SERVICE BULLETIN

Model 1992 PRELUDE	Applicable To ALL	File Under BODY	Bulletin No. 92-028
			Issue Date AUG 28, 1992

Squeaking From Closed Sunroof

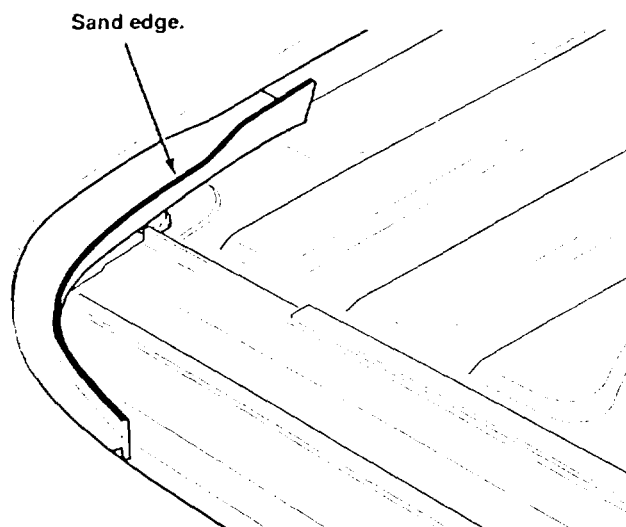
A squeaking noise in the rear of the sunroof panel when driving on rough roads with the sunroof closed.

Interference between the sunroof panel and the rear drain channels. In most cases the rear corners of the sunroof panel sit below the roof panel.

Measure the height of the sunroof panel according to the procedure on page 20-30 of the service manual. Depending on this measurement, do Procedure A or B.

Procedure A: Sunroof panel sits less than 1.4 mm above roof.

1. Remove the sunroof panel liner.
2. Install a sunroof shim on the side that squeaks.
3. Install the sunroof panel liner.

Procedure B: Sunroof panel sits more than 1.4 mm above roof.

1. Remove the sunroof panel liner.
2. Remove the sunroof panel.

3. Sand the edge of the rear drain channel on the side that squeaks to remove any high spots.

4. Install the sunroof panel and adjust it for proper height.
5. Install the sunroof panel liner.
